# RAILROAD COMMISSION OF TEXAS

## PROPOSAL FOR DECISION

OIL AND GAS DOCKET NO. 06-0290629

THE APPLICATION OF BP AMERICA PRODUCTION COMPANY, TO AMEND FIELD RULES FOR THE OAK HILL (COTTON VALLEY) FIELD, GREGG, HARRISON, PANOLA, AND RUSK COUNTIES, TEXAS

#### ATTACHMENT E

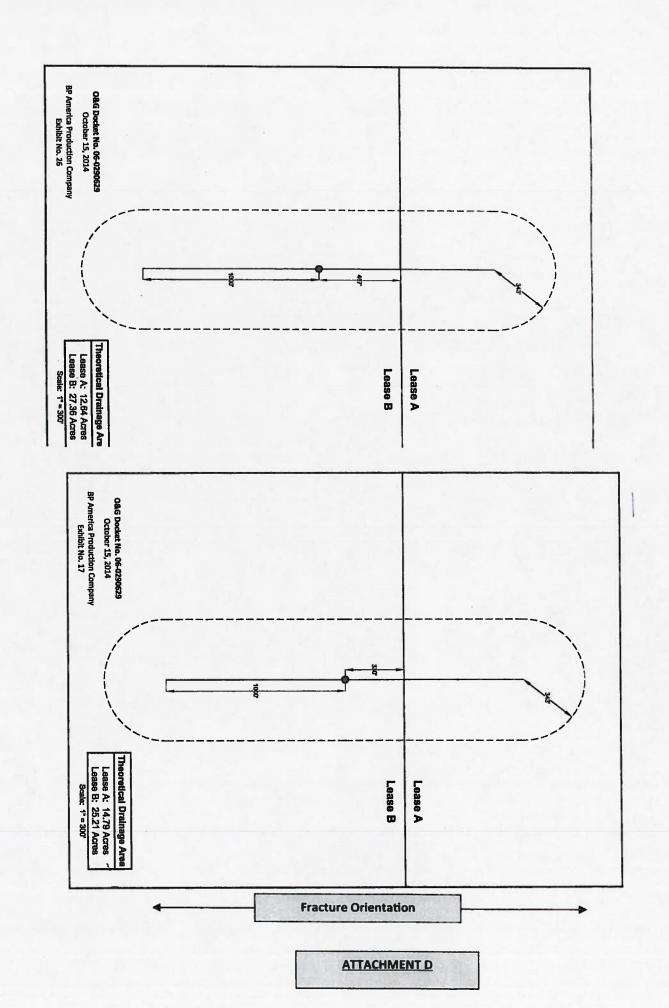
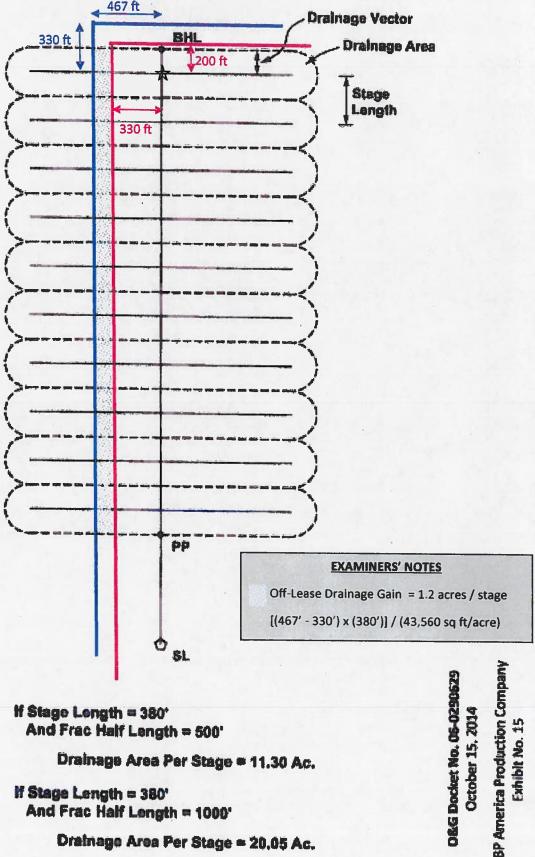
#### **EXAMINERS' NOTES**

**Current Spacing Rules for** Horizontal Wells (blue):

330 feet - first and last take points to a lease line.

467 feet - all take points to a lease line when measured perpendicular to the lateral

**Proposed Spacing Rules for** Horizontal Wells (red):

200 feet - first and last take points to a lease line. NOTE: Examiners recommend this change be approved.

330 feet - all take points to a lease line when measured perpendicular to the lateral. NOTE: Examiners recommend this change be denied.
